**Addendum No. 2**  
**November 17, 2021**

Project: Corsica-Stickney H.S. Addition  
Corsica, South Dakota  
Architect's Project No.: 2910

Architect: Architecture Incorporated

5 SF3 ELEVATION  
5.11 SCALE: 1/4" = 1'-0"

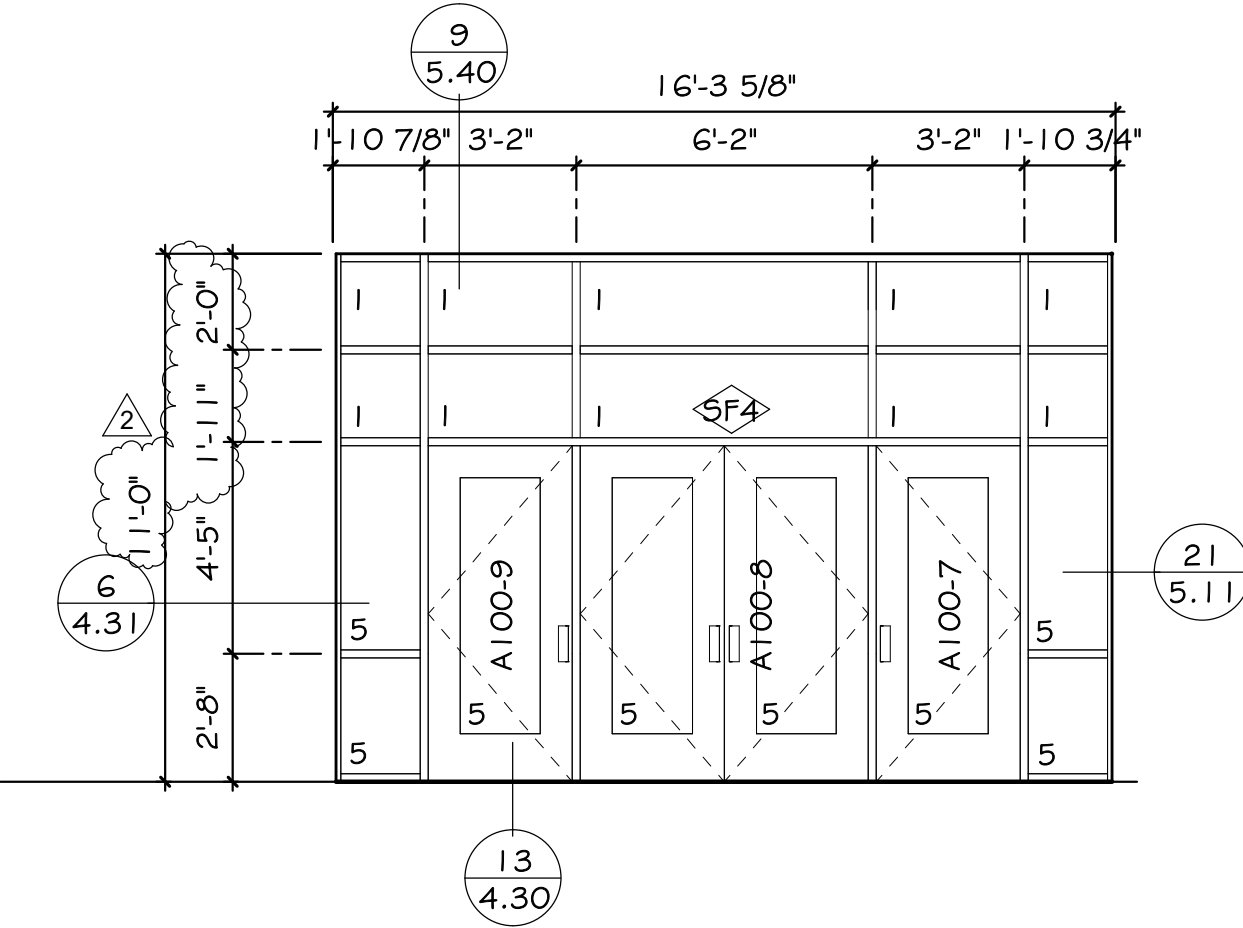
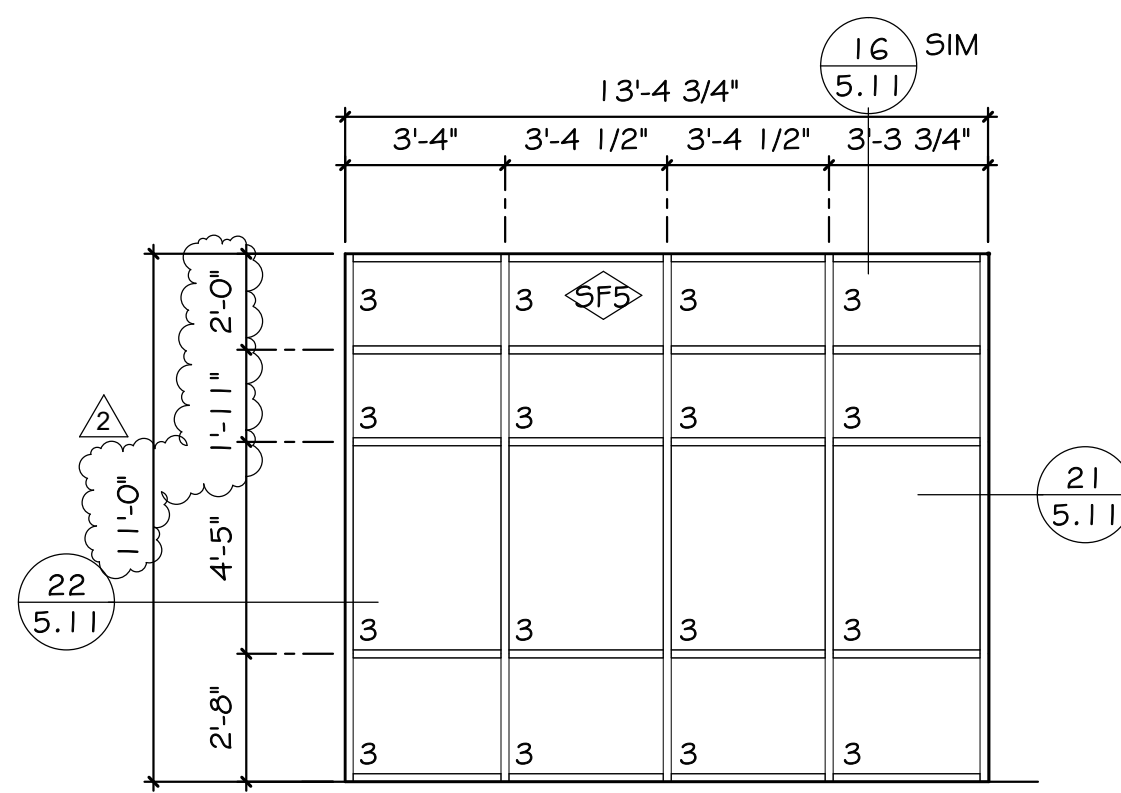
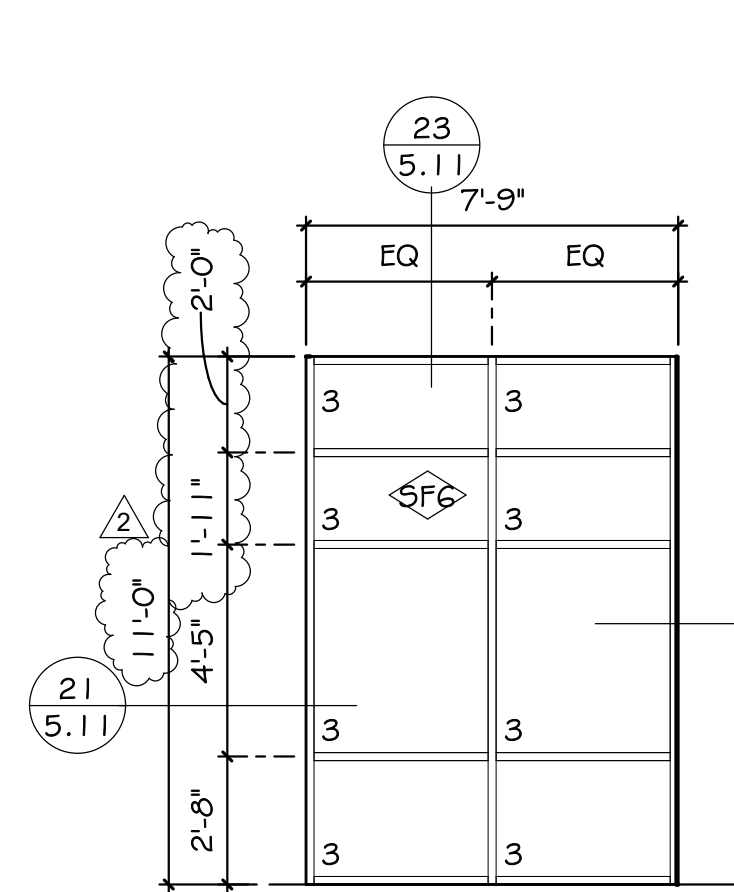
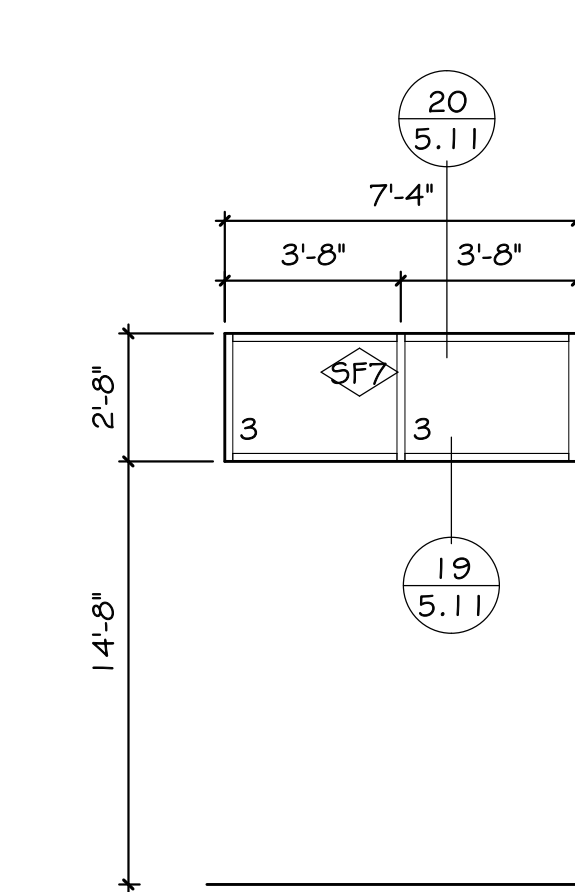
- a) **MODIFY** Storefront SF3, SF4, SF5 and SF 6 to 11’-0” in height
  - b) **MODIFY** Details 16/5.11 and 23/5.11
- 10) **SHEET 5.40 SECTION DETAILS:** See new sheet clouded and tagged with “2”
